## VILLAS AT CLAREMONT RANCH PUD PRELIMINARY PLAN

### LETTER OF INTENT

DECEMBER 2020, REVISED MARCH 2022

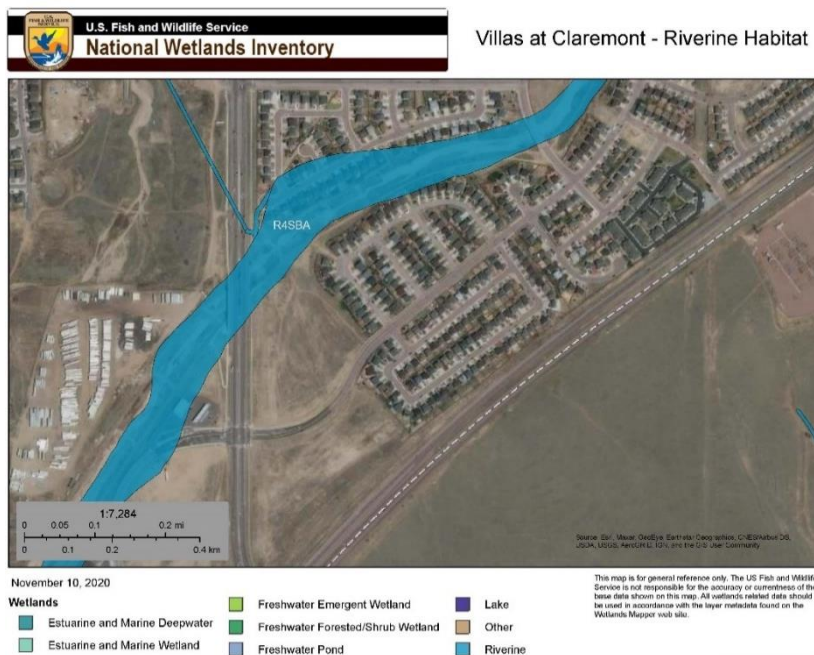
There is currently an application to change this. We cannot ignore if this is going to be used as a justification for compatible land use.
